STAFF RECOMMENDATION

1501 Cedar Lane

July 21, 2021

Application: New construction- Outbuilding

Figure 2. Heights of house and DADU

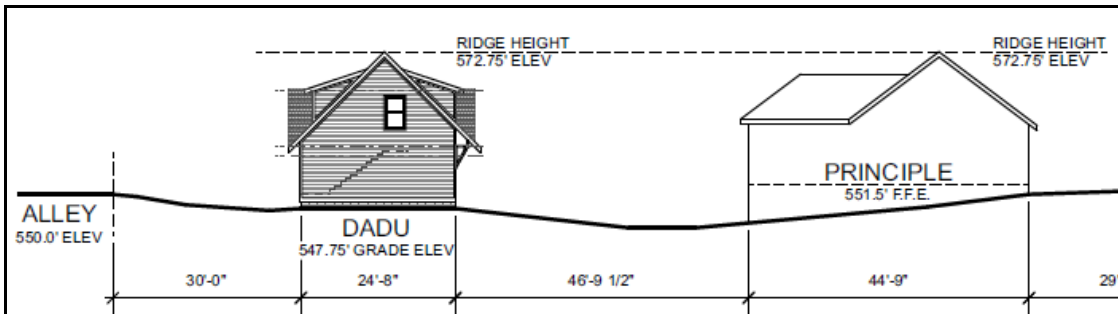
The proposed ridge height will be twenty-five feet (25') tall from grade which is more than the twenty-foot (20') tall house, as measured from finished floor. See Figure 3. The Commission has previously considered the height of primary structures from finished floor to help account for changes in grade. This house is a good example of a primary structure that picks up some foundation height in the rear, but where the primary structure is quite modest. See Figure 2. The proposed eave height will match the historic eaves at about eight feet, six inches (8'6").

Staff finds that the ridge height needs to be reduced to be no more than twenty feet (20') from grade, so that the height does not exceed that of the historic house. With the reduction in ridge height, the proposal will meet Section II.B.1.i of the design guidelines.

Figures 4 & 5 – side elevation and house-facing elevation

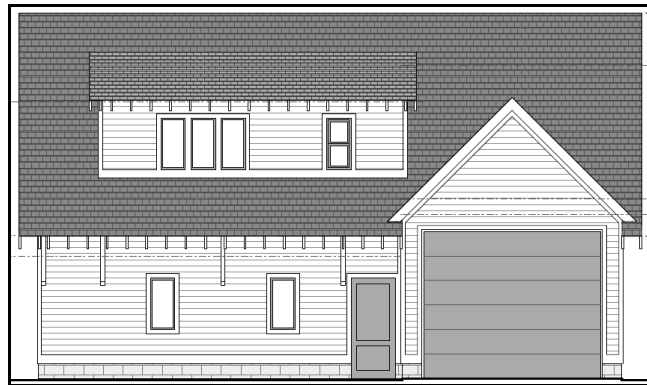
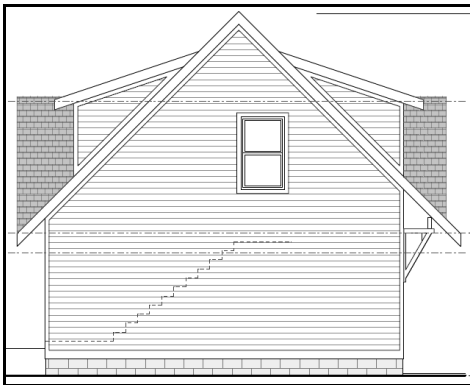
The lap siding should be smooth-faced, either hardie board or wood, with a maximum exposure of five inches (5”). The cement block should be split-faced or shall have a parge coat. With staff’s final approval of the masonry, cladding, roof color, windows, doors and garage doors, staff finds that the materials meet Section II.B.1.d of the design guidelines.

1501 CEDAR DADU
REAR (ALLEY) ELEVATION • SCALE: 1/4"=1'

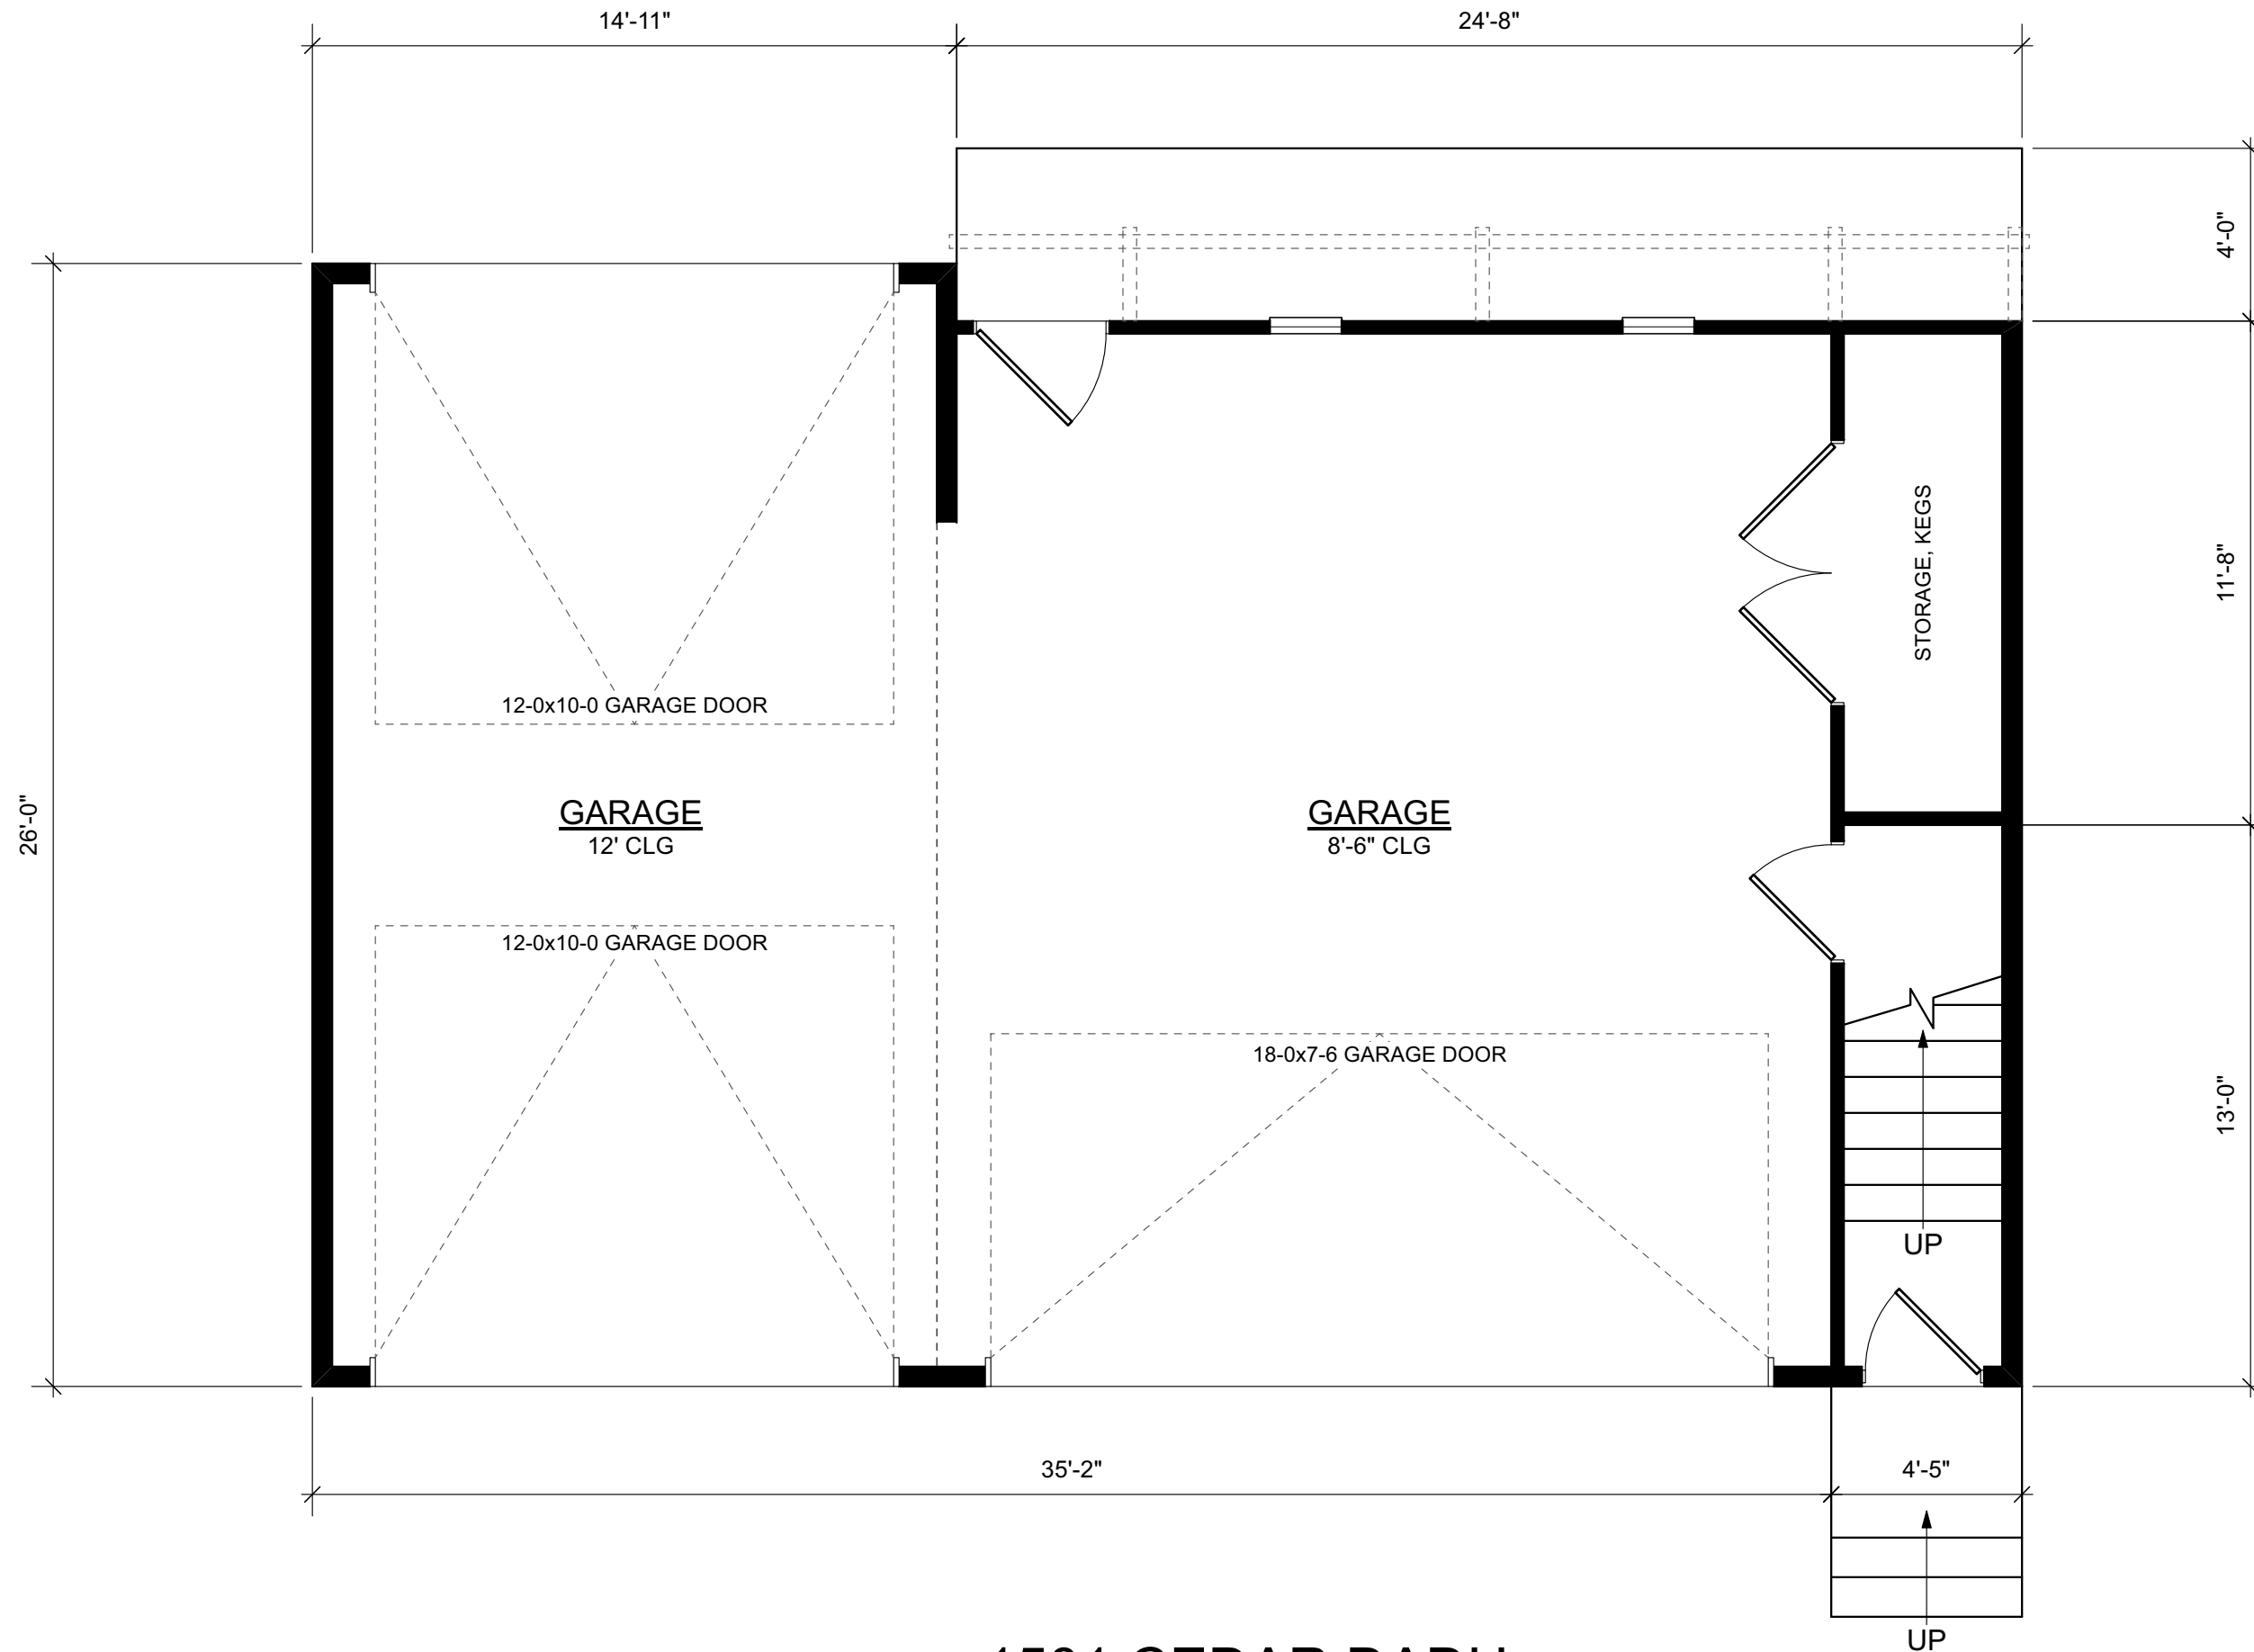
The dormers are appropriately sized, but the dormer on the alley-facing elevation is not inset two feet (2') from the wall below. See Figure 3. This dormer should be inset the required two feet (2').

With the condition that the dormers are both inset the required two feet (2') staff finds that the project meets section II.B.1.i of the design guidelines.
